MEMORANDUM

To: Jose Lopez, Project Manager, SDG&E
From: Jing Liang 
Date: 4/16/2010
Re: Mitigation Measure H-8a: Scour and Erosion Protection at Creek Crossings

RESPONSE TO MITIGATION MEASURE, H.8a: BURY POWER LINE BELOW 100-YEAR SCOUR DEPTH.

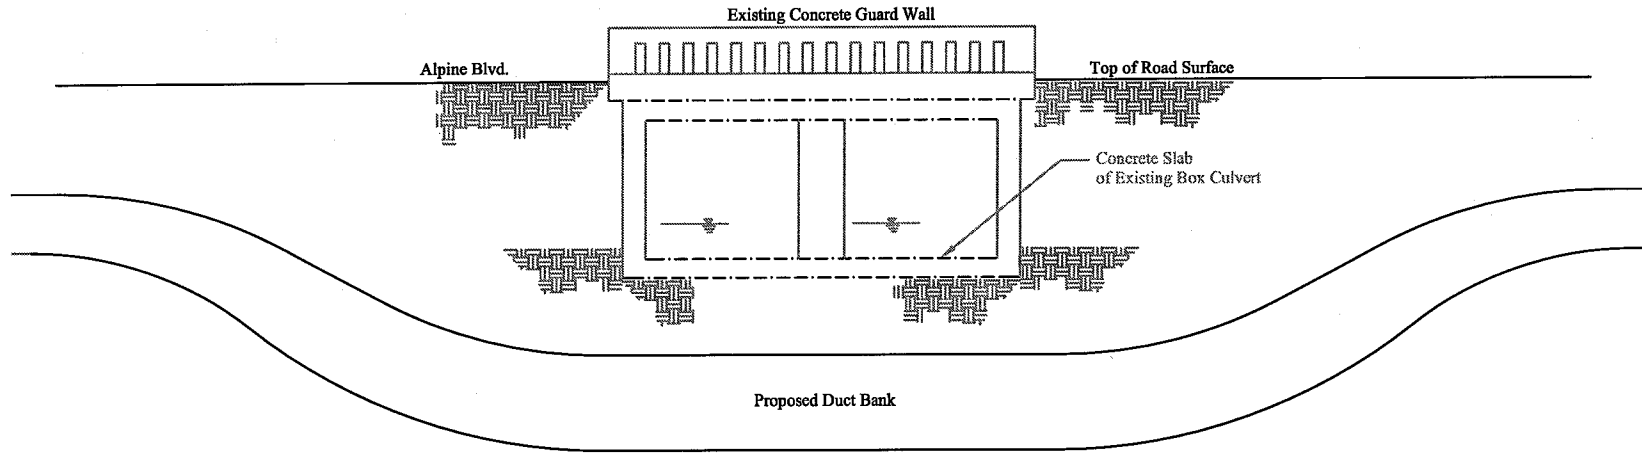
4. **Data Response:** Please confirm that the existing culvert crossing at Alpine Blvd. is structurally sound and has not experienced any excessive scour or undercutting of its entrance and exit concrete aprons (slabs).

5. **Data Request:** Please confirm that the existing stream course both upstream and downstream of the culvert crossing at Alpine Blvd. is not excessively erosive in nature and that no observable channel knick point exists that may migrate toward the crossing structure.

Response: Field inspection was made and verified that there is not any cracking or spalling from existing concrete structure, and there is not any visible excessive scour or undercutting of the entrance and exit concrete slabs.

Response: From field inspection, B&V confirmed that existing stream course both upstream and downstream of the culvert crossing at Alpine Blvd. is not excessively erosive in nature and that no observable channel knick point exists that may migrate toward the crossing structure.

Alpine Blvd. (Creek Crossing)

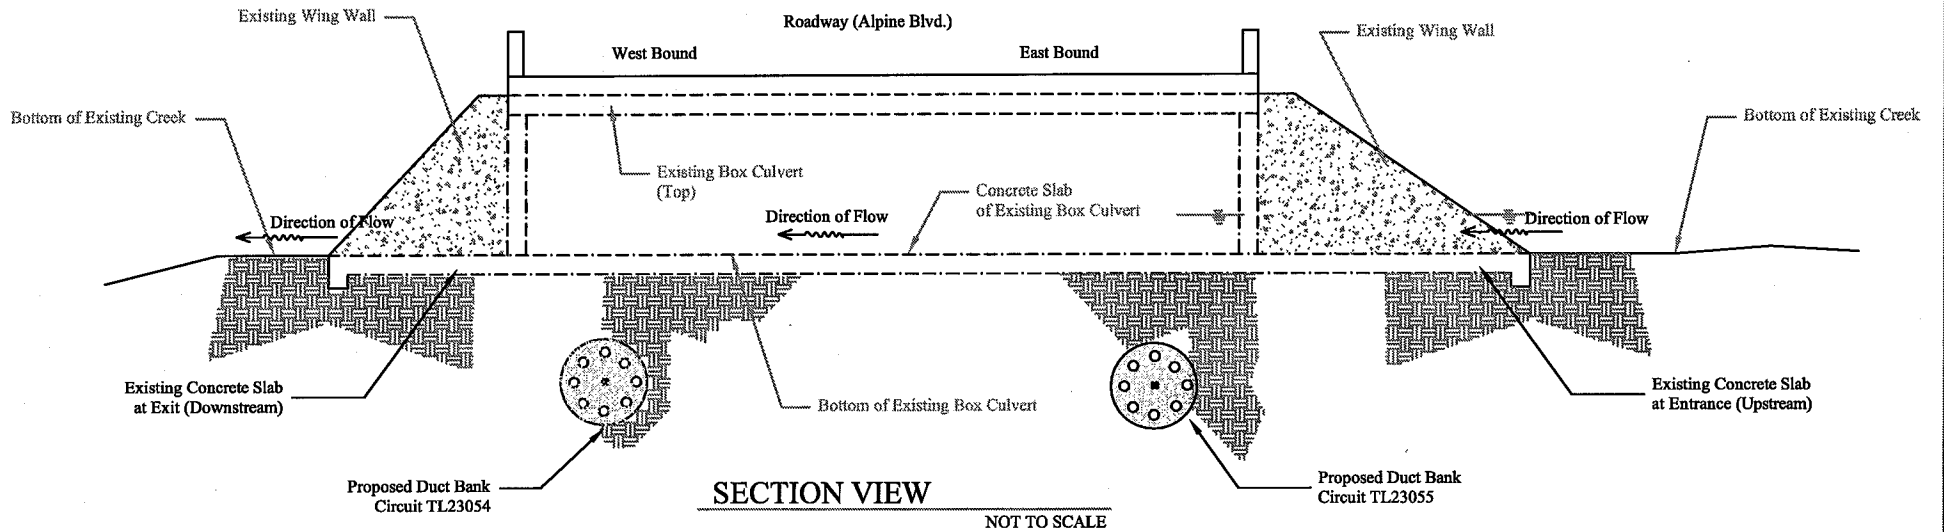
1. **Data Request:** Please confirm that the basis of design for the transmission line crossing considered the structural design and integrity of the existing culvert and that the culvert crossing was engineered to operate and function for flows equaling the estimated 100-yr discharge event.

2. **Date Request:** Please confirm that the concrete entrance and exit slabs that extend upstream and downstream of the Alpine Blvd. culvert crossing were engineered in consideration of potential erosive and scour conditions along the creek channel associated with large flow events (100-yr event) as well as, smaller more frequent events.

Response: B&V had discussed with County of San Diego, and confirmed the existing box culvert installed on Alpine Blvd. at approx. 600 feet east of Marshall Road was designed to meet 100-year storm event. B&V confirmed the basis of design for the transmission line does not impact any structural design and integrity of the existing structure.

Response: B&V confirmed that the concrete entrance and exit slabs that extended upstream and downstream at the box culvert were intended and engineered in consideration of the potential erosion and scour protection from large flow events (100-year storm) and smaller, but more frequent events.

B&V also corrected the typo error on the drawing and included the direction of water flow as noted in the data request on 3/23/10. Please see attached revised sketch.
